Access Compliance Report

Public Rights-of-Way (Curb Ramps)

Intersection ID: N/A	Main Street: HATTON_CROSS_DR	Cross Street: DERWENT_CT	Location: NE
ADA ID: 2DE4DC34B687	Ramp Type: Directional1	Initial Pass/Fail: Fail	Overall Compliance: No
		Severity Score: 1.25

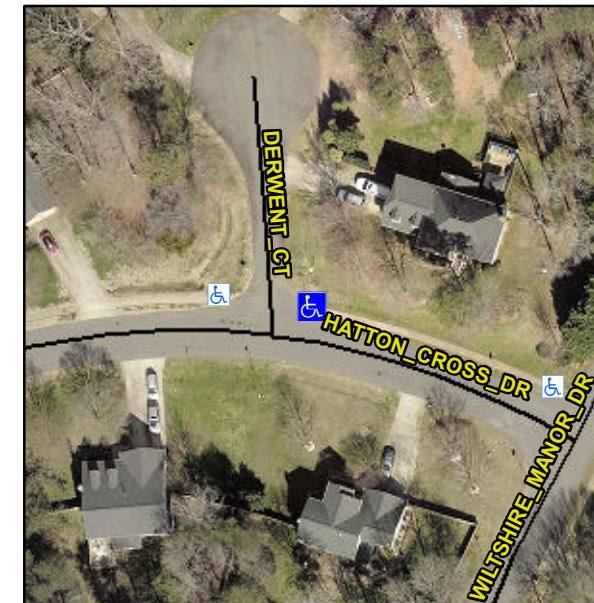
R304.5.3

Compliance	Description	Data	Compliance	Description	Data
N/A	Ramp Length (in)	48.0	N/A	Grade Break?	N/A
Yes	Ramp Width (in)	48.0	N/A	Grade Break Slope (%)	0.0
Yes	Ramp Slope (%)	3.2	N/A	Grade Break XSlope (%)	0.0
No	Ramp XSlope (%)	2.2			
N/A	Flare Type LT	N/A	N/A	Flare Type RT	N/A
N/A	Flare Slope LT (%)	N/A	N/A	Flare Slope RT (%)	0.0
N/A	Flare Traversable LT?	N/A	N/A	Flare Traversable RT?	N/A
N/A	Landing Length (in)	0.0	N/A	DWS Provided?	N/A
N/A	Landing Width (in)	0.0	N/A	DWS Contrast?	N/A
N/A	Landing Slope (%)	0.0	N/A	DWS Length (in)	N/A
N/A	Landing X Slope (%)	0.0	N/A	DWS Full Width?	N/A
N/A	Landing Curb? (Y/N)	N/A	N/A	DWS Offset LT (in)	N/A
N/A	Shared Landing?	N/A	N/A	DWS Offset RT (in)	N/A
N/A	Gutter Ponding?	0.0	N/A	Gutter Slope (%)	N/A
N/A	Gutter Lip Ht (in)	0.0	N/A	Gutter X Slope (%)	N/A
N/A	Painted X Walk1?	No		Road Slope (%)	1.4
	X Walk 1 Direction	To W		Road X Slope (%)	3.4
	X Walk 1 Width (in)	N/A		Clear Space?	N/A

Remove & Replace Entire Ramp.
